APPLICATION NO.	FILING DATE	FIRST NAMED INVENTOR	ATTORNEY DOCKET NO.	CONFIRMATION NO.
10/526,795	09/19/2005	Hermann Franzen	MOS01 P-122	7394
28101	7590	09/10/2007	EXAMINER	
VAN DYKE, GARDNER, LINN & BURKHART, LLP SUITE 207 2851 CHARLEVOIX DRIVE, S.E. GRAND RAPIDS, MI 49546			CHIN, PAUL T	
ART UNIT		PAPER NUMBER		
3652				
MAIL DATE		DELIVERY MODE		
09/10/2007		PAPER

Office Action Summary	Application No.	Applicant(s)	
	10/526,795	FRANZEN ET AL.	
Examiner	Art Unit		
PAUL T. CHIN	3652

DETAILED ACTION

Exhibit A

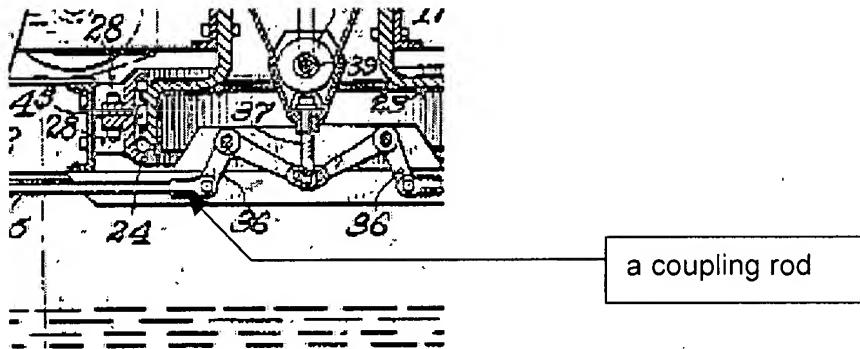
Re claims 17-19, the modified Weickel (1,270,995) teaches a second lever (36) (see Fig. 2) and a coupling rod (see Exhibit A) connected to the lever arm (36) and the guiding bar (35).

Re claim 20, figure 2 of the modified Weickel (1,270,995) teaches a lifting rod (33), which is a means (30,33) for guiding the bar to the load receiving device.
